1/9 Agenda --Solana RV Resort Development Master Plan CC DMP-23-055 ** QUASI ** Subject:

At the request of a Commissioner, attached please find attached the Traffic Impact Study for Item #5. Public Hearings, C. CC DMP-23-055 Solana RV Resort Development Master Plan (QUASI-JUDICIAL) on the January 9, 2024 City Commission Regular Meeting Agenda.

Attachments: IMG 2255.PNG

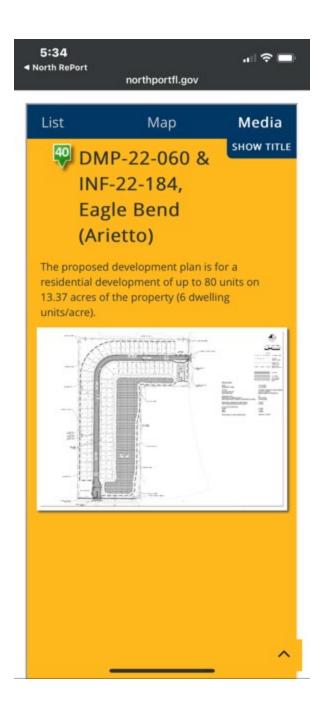
Pictured below is the housing development planned to the east side of the Solana RV Park. I have been told it is "on hold" due to issues with water runoff. Question: if it is true that this pictured project is on hold due to possibly causing neighboring properties harm; then how is it that the RV park would not have the same problem?
